8 September 2022

SECTION 4.55(1A) MODIFICATION REPORT JOHN HUNTER HEALTH AND INNOVATION PRECINCT, LOOKOUT DRIVE, NEW LAMBTON HEIGHTS

Figure 3 Proposed ASB alignment

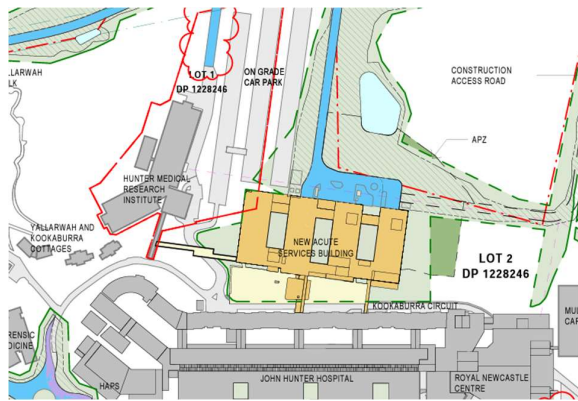
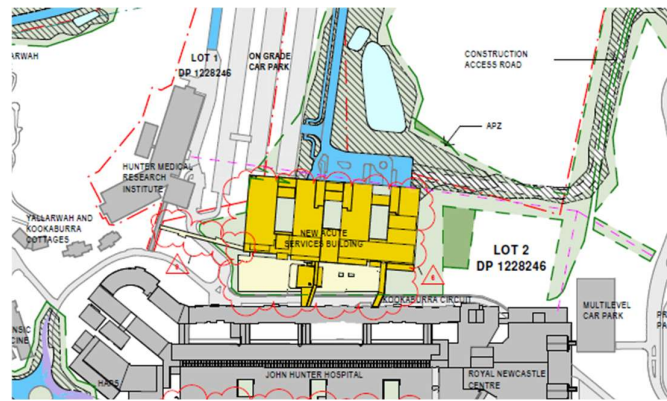
A comparison of the ASB as approved and as proposed is shown at **Figure 1** and **Figure 2** below.

6	ASB relocation and rotation	This modification proposes to rotate the ASB building slightly. The rotation of the building pushes the orientation closer to true north without losing the opportunity to open up towards the Hunter Medical Research Institute (HMRI). Slight movement further away from the existing JHH enables separation from the existing façade of the JHH and improves the amount of space for the end user in the ED drop off area. The original design for the Acute Services Building (ASB) included the construction of an approximately 12m high shoring wall along the southern edge of the building. Completion of additional geotechnical investigations and subsequent subsurface strata modelling determined that construction of this shoring wall would present a significant slope stability risk for the existing John Hunter Hospital during the construction period. The proposed modified design seeks to move the building to the north varying up to 10m, including a small counter clockwise rotation in order to provide additional room for battering of the excavation rather than installing a vertical shoring wall.
